Project	IEEE 802.16 Broadband Wireless Access Working Group < http://ieee802.org/16 >	
Title	Action Item from Session # 48: Credit token based coexistence protocol text update	
Date Submitted	2007-05-09	
Source(s)	David Grandblaise Motorola Labs Parc Les Algorithmes Commune de Saint Aubin 91193 Gif sur Yvette, France	Voice: +33 (0)1 6935 2582 Fax: +33 (0)1 6935 4801 mailto: david.grandblaise@motorola.com
Re:	Working Group Letter Ballot #24a for IEEE P80216h/D2a	
Abstract	During sessions # 48, several comments (2127, 2148L, 2149L, 2150L) were made to update and clean up text related to the credit token based coexistence protocol. This contribution provides some text remedy proposals for these comments to be included within IEEE 802.16h/D2a, and consolidates the previous preliminary contribution [3].	
Purpose	Action Item from Session # 48: Credit token based coexistence protocol text update	
Notice	This document has been prepared to assist IEEE 802.16. It is offered as a basis for discussion and is not binding on the contributing individual(s) or organization(s). The material in this document is subject to change in form and content after further study. The contributor(s) reserve(s)

Figure ha: Master subframe (OFDM symbols) sharing within CXCC

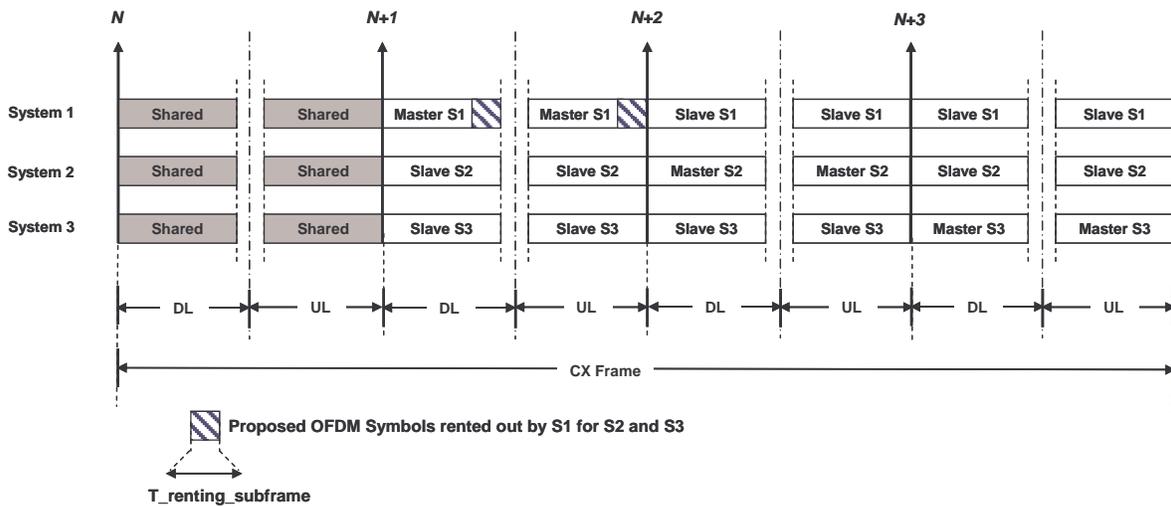
In some traffic conditions circumstances, some master subframes are temporally under-used by some BS (offering BS, namely offeror) due to some low traffic activity while some of its neighboring BSs (requesting BS, namely requester) require temporally some additional master sub frame capacity to face some traffic increase. With respect to this, master sub frame sharing between neighbouring systems contributes for better spectrum efficiency. The typically operation of sharing is illustrated in Figures ha and hb where system S1 proposes to rent out its assigned last OFDM symbols (for a time duration $T_{renting_subframe}$ per master subframe over several consecutive CX frames of total time duration $T_{renting_epoch}$) to system S2 and S3. This master sub frame sharing is supported by the credit token based coexistence protocol (CT-CXP). CT-CXP provides the means for an offeror to rent out temporally some of its master sub frame capacity to some competing requester(s) willing to rent in simultaneously this proposed additional resource. CT-CXP guarantees exclusive access of the offeror's unused master subframe resource to the requester(s) for an agreed time period between the offeror and the requester. During this agreed period, the requester is granted with the resource during which the offeror will not use the resource. Also, CT-CXP ensures over time a fair access of the offeror's master subframe available resource between competing requesters.

Figure hc: Whole CT-CXP Procedure

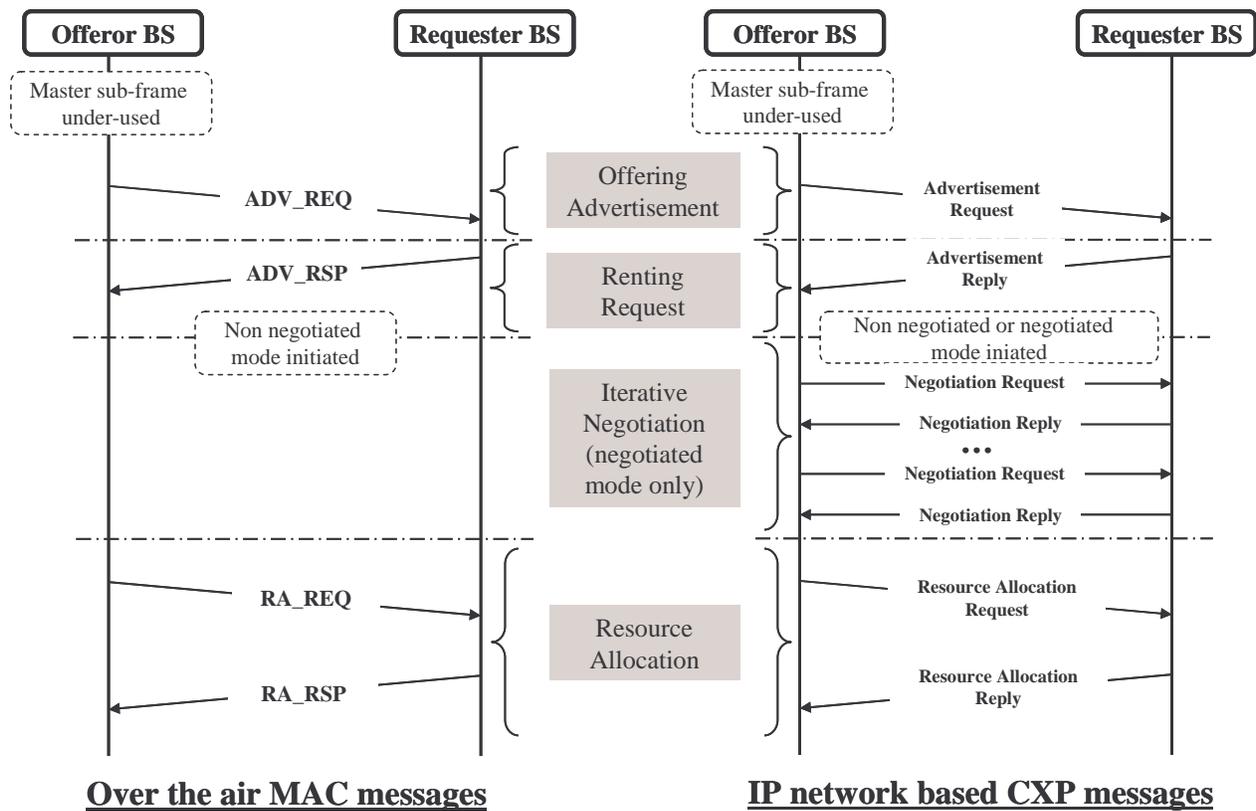
CT-CXP is composed of several consecutive procedures (offering advertisement, renting request, iterative negotiation, and resource allocation) as shown in Figure hc. For the sake of simplicity, this figure is only depicted for one (among multiple) requesters. Over the air based instantiation of CT-CXP for the non negotiated mode is depicted on the left hand side of Figure hc. The over IP network based instantiation of CT-CXP for the negotiation or non negotiated mode is depicted on the right hand side of Figure hc. MAC messages related to the over the air instantiation are specified in section 6.3.2.3. Inter system over the air communications mechanisms are described in subclause 15.x. CXP messages related to IP network based instantiation are specified in section 15.5.1. The offering advertisement message (Advertisement Request) specifies which negotiation mode is used by the CT-CXP. The iterative negotiation procedure is executed only with the negotiated mode and not with the non-negotiated mode.

Figure hd: Over the air based CT-CXP offering procedure

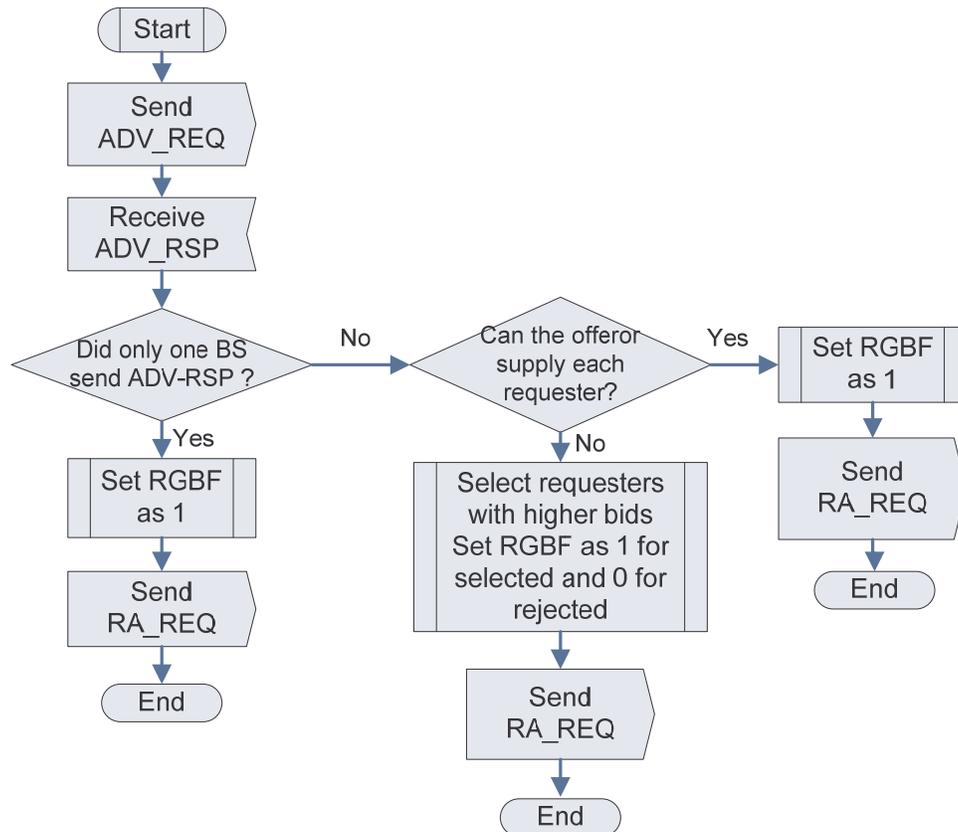
a) The procedure described in Figure hd is as follows:

- A BS identifies that a part of its master subframe is going to be under-used and can be rented out. With respect to this, this BS becomes an offeror BS and initiates the renting advertisement by broadcasting the ADV_REQ message. In particular, this message includes information related to the available resource ($T_{renting_subframe}$, $Renting_out_start_time$, $Renting_out_end_time$) as well as the renting conditions (MNCT: Minimum number of credit tokens per resource unit required per requester’s bid).

- If the offeror BS receives one single ADV_RSP message, then the offeror BS grants the renting resource to the single requester by setting the Resource Granting Bit Flag (RGBF) to 1 in the RA_REQ message. The granted requester is not charged with credit token since it is not competing with some other requesters.

- If the offeror BS receives more than one ADV_RSP message, then it assesses whether he can supply each requester or not:
 - If it can supply, the offeror BS grants the renting resource to all requesters by setting the Resource Granting Bit Flag (RGBF) to 1 in the RA_REQ message.

- If it cannot, the offeror BS derives and selects requesters with higher bids based on the information received from competing requesters. The offeror BS grants the resource to the selected requesters by setting the Resource Granting Bit Flag (RGBF) to 1 in the

RA_REQ message. These selected requesters can access to their requested resource Rented_resource_amount from Renting_subframe_start_time to Renting_subframe_end_time during the guaranteed requested time period (Renting_in_start_time, and Renting_in_end_time). RGBT is set to 0 for the non selected requesters.

- The RA_REQ message includes the clearing price (Clearing_price) mentioning the number of credit tokens the requester has to freeze to acquire the granted resource.

Figure he: IP network based CT-CXP offering procedure

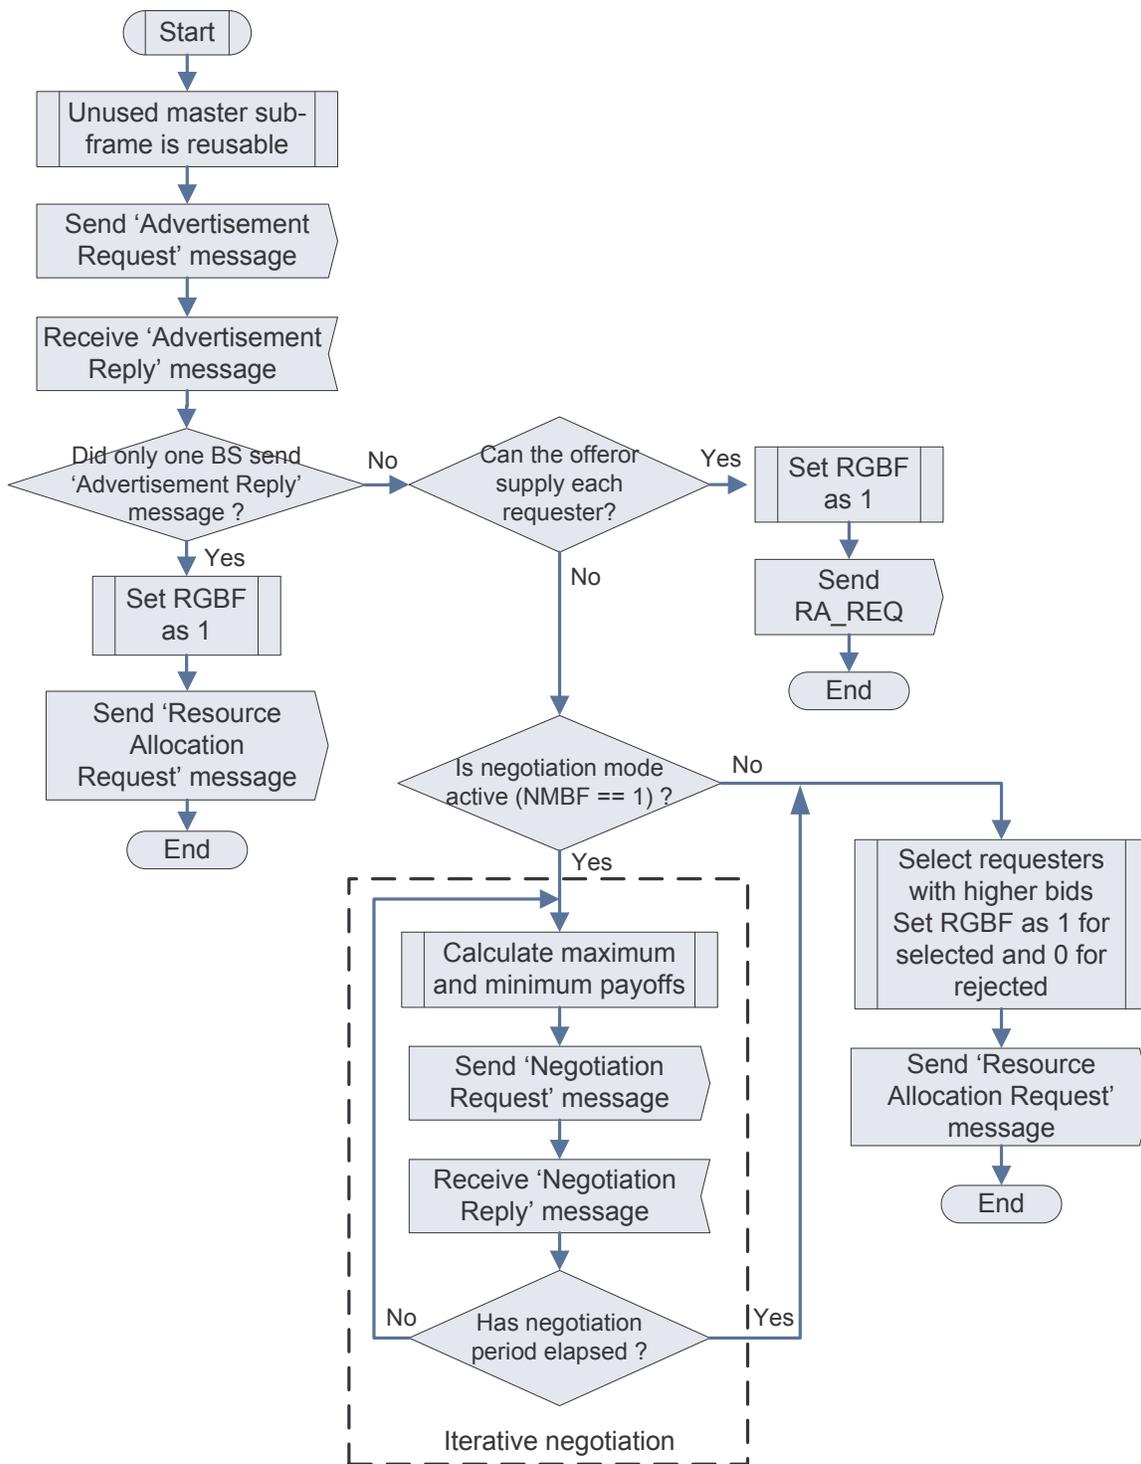
b) The procedure described in Figure he is as follows:

- A BS identifies that a part of its master subframe is going to be under-used and can be rented out. With respect to this, this BS becomes an offeror BS and initiates the renting advertisement by broadcasting the “Advertisement Request” message. In particular, this message includes information related to:

- The available resource (T_renting_subframe, Renting_out_start_time, Renting_out_end_time),
 - The negotiation mode (NMBF == 0: non negotiated mode is active, NMBF == 1: negotiated mode is active),

- The renting conditions (Start_negotiation_time, End_negotiation_time, MNCT),
 - The pricing method in case NMFF == 1.
- If the offeror BS receives one single “Advertisement Request” message, then the offeror BS grants the renting resource to the single resquester by setting the Resource Granting Bit Flag (RGBF) to 1 in the “Resource Allocation Request” message. The granted requester is not charged with credit token since it is not competing with some other requesters.

- If the offeror BS receives more than one “Advertisement Request” message, then it assesses whether he can supply each requester or not:
 - If it can supply, the offeror BS grants the renting resource to all requesters by setting the Resource Granting Bit Flag (RGBF) to 1 in the “Resource Allocation Request” message.

- If it cannot, the offeror BS follows the negotiated mode under consideration:
 - If NMBF == 0, same procedure as a) is executed. The Offeror BS derives and selects requesters with higher bids based on the information received from competing requesters. The offeror BS grants the resource to the selected requesters by setting the Resource Granting Bit Flag (RGBF) to 1 in the “Resource Allocation Request” message. These selected requesters can access to their requested resource Rented_resource_amount from Renting_subframe_start_time to Renting_subframe_end_time during the guaranteed requested time period (Renting_in_start_time, and Renting_in_end_time). RGBT is set to 0 for the non selected requesters.

- If NMBF == 1, iterative negotiation occurs between the offeror BS and each requester BS. Based on the information received within the “Advertisement Reply” message, the offeror BS calculates respectively a minimum and maximum payoff (Minimal_payoff and Maximal_payoff) at each iteration. These payoffs allow selecting the remaining requesters at each iteration. An example of payoff calculation is given in section 15.4.2.4.2. At each iteration, Minimal_payoff and Maximal_payoff are sent within the “Negotiation Request” message. The iterative negotiation occurs until the negotiation period (bounded by End_negotiation_time) is elapsed. At the end of the negotiation, the final requesters are selected by the offeror BS. The offeror BS grants the resource to the selected requesters by setting the Resource Granting Bit Flag (RGBF) to 1 in the “Resource Allocation Request” message. These selected requesters can access to their requested resource Rented_resource_amount from Renting_subframe_start_time to Renting_subframe_end_time during the guaranteed requested time period (Renting_in_start_time, and Renting_in_end_time). RGBT is set to 0 for the non selected requesters.

Figure hf: Over the air based CT-CXP requesting procedure

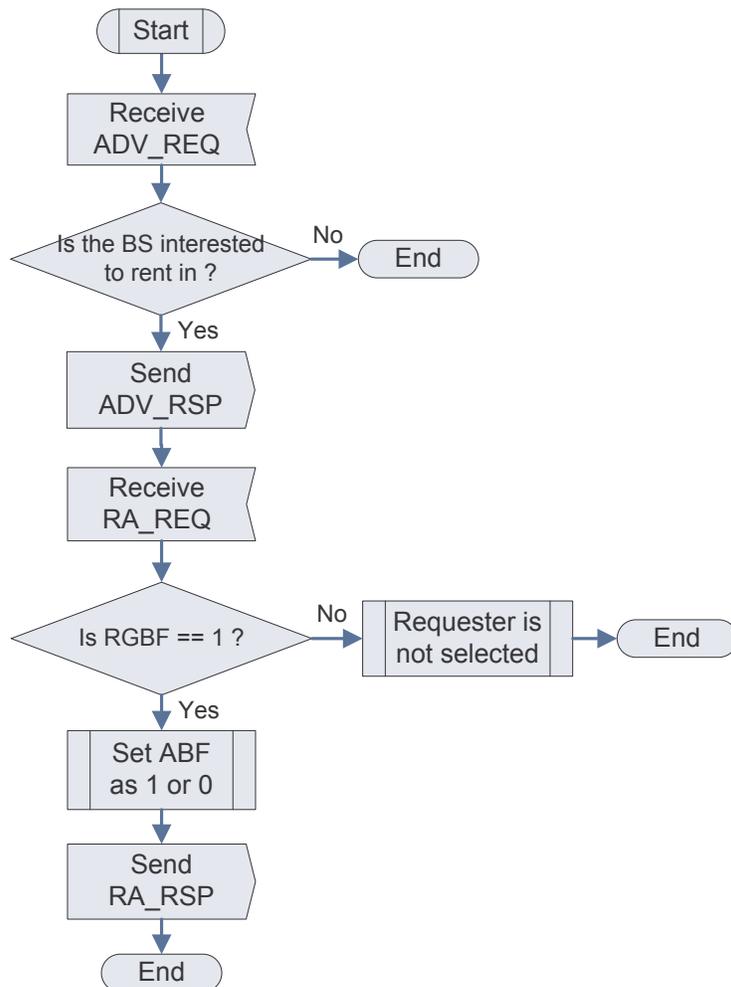
a) The procedure described in Figure hf is as follows:

- If a BS is in need of additional resource and can meet MNCT requirements, he can make a request (ADV_REQ message) upon the reception of ADV_REQ.
- Within ADV_RSP, the requester informs about the amount of required resource (Rented_resoure_amount), the rented in start and end time (Renting_in_start_time, Renting_in_end_time) and the requester’s bid (Requester_bid) in term of number of credit tokens bidded per resource unit.

- Upon reception of RA_REQ message, the requester BS knows whether it has been selected or not. If RGBF is set to 1, the requester BS is selected, otherwise (RGBF set to 0) the requester is rejected.

- The requester decides to accept (Acceptation Bit Flag ABF set to 1) or to reject (ABF set to 0) the resource granting based on the Clearing_price information. This information is sent within the RA_RSP message.

- If ABF is set to 1, a number of credit tokens equal to the clearing price will not be usable (for some other renting requests by this requester) for a time duration equal to [renting_in_start_time; renting_in_end_time + δ] where δ is a frozen period margin. This ensures fairness over time between competing requester BSs to access to some other renting offers.

Figure hg: IP network based CT-CXP requesting procedure

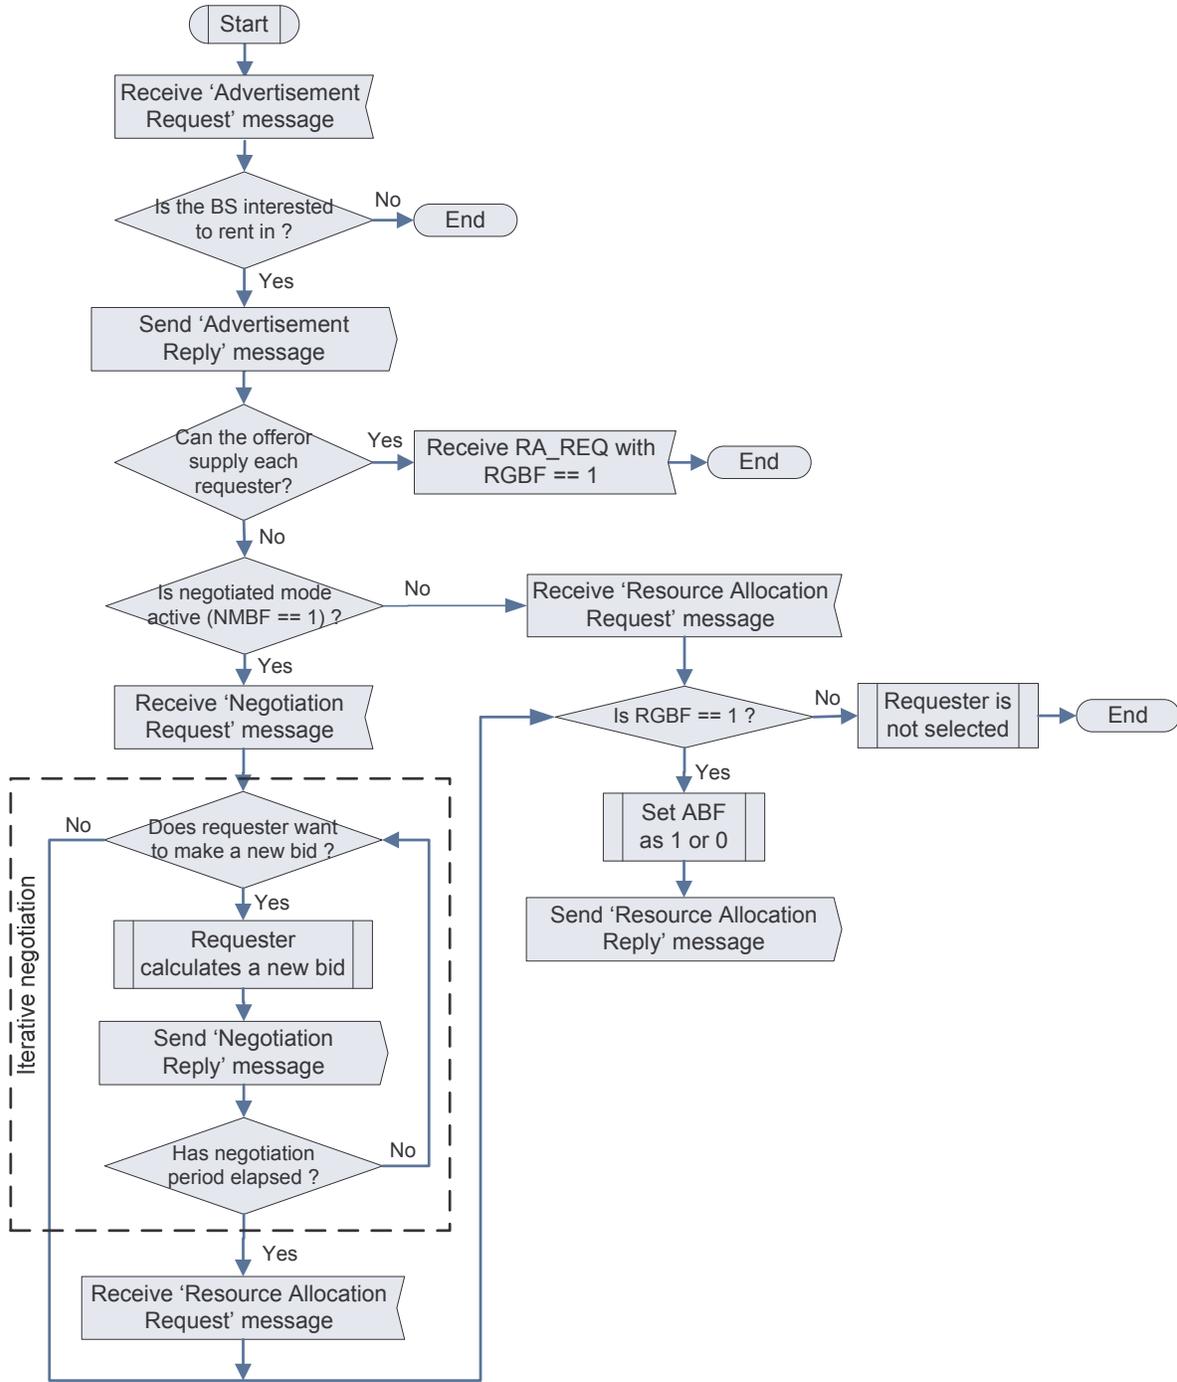
b) The procedure described in Figure hg is as follows:

- If a BS is in need of additional resource, meets MNCT requirements, and agree with the proposed negotiation mode (NMBF) and pricing method (PBF) specified within the “Advertisement Request” message, he can submit a bid (“Advertisement Reply” message) upon the reception of the “Advertisement Request” message.

- Within the “Advertisement Reply” message, the requester informs about the amount of required resource (Rented_resource_amount), the rented in start and end time (Renting_in_start_time, Renting_in_end_time) and the requester’s bid (Requester_bid) in term of number of credit tokens bid per resource unit.

- If the non negotiation mode is active (NMBF == 0), same procedure as a) is executed. If the offeror BS can supply to the requester BS, the offeror BS grants the renting resource by setting the Resource Granting Bit Flag (RGBF) to 1 in the “Resource Allocation Request” message.

- If the negotiation mode is active (NMBF == 1), iterative negotiation occurs between the offeror BS and each requester BS. At each iteration, based on the information Minimum_payoff and Maximal_payoff received from the “Negotiation Request” message, the requester decides to submit a new bid (Requester_bid_update) or not. Requester_bid_update is sent within the “Negotiation Reply” message. The iterative negotiation occurs until the negotiation period (bounded by End_negotiation_time) is elapsed.

- Upon reception of the “Resource Allocation Request” message, the requester BS knows whether it has been selected or not. If RGBF is set to 1, the requester BS is selected, otherwise (RGBF set to 0) the requester is rejected.

- The requester decides to accept (Acceptation Bit Flag ABF set to 1) or to reject (ABF set to 0) the resource granting based on the Clearing_price information. This information is sent within the “Resource Allocation Reply” message.

- If ABF is set to 1:
 - If PBF == 0, a number of CTs equal to the $\text{Clearing_price} \times \text{Rented_resource_amount} \times \text{T_renting_subframe} \times (\text{Renting_in_end_time} - \text{Renting_in_start_time}) / \text{CX_Frame_duration}$ is transferred from the requester’s ownership to the offeror’s one.

- If PBF == 1, the CT are not transferred but remains to the requester ownership. However, a number of credit tokens equal to the clearing price will not be usable (for some other renting requests by this requester) for a time duration equal to $[\text{renting_in_start_time}; \text{renting_in_end_time} + \delta]$ where δ is a frozen period margin. This ensures fairness over time between competing requester BSs to access to some other renting offers.

Figure h69—Architecture for coexistence of BWA and preferred radio applications

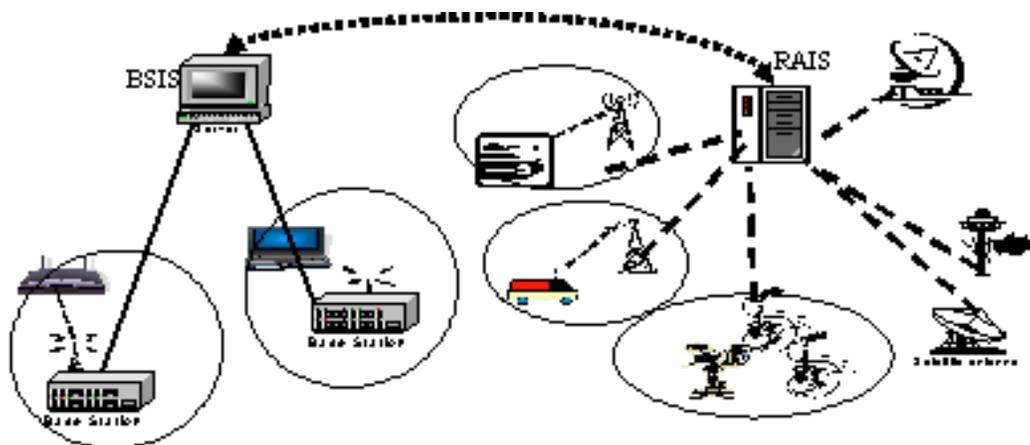
[Update text of section 15.7 as indicate:]

In addition to these functions, this architecture can also serve for the administration of the credit tokens to be used for the CT-CXP operations. For that purpose, RAIS can specify to BSISs some policies (ruling) for the usage of the credit tokens for the BS covered by this BSIS. For example, polices can specify the number of credit tokens to be assigned to each BS at some given locations or some given time periods, the negotiation mode, the pricing method, and so forth. The BSIS communication with RAIS is supported by the Coexistence Protocol messages Regulatory Authority Request and Regulatory Authority Response.
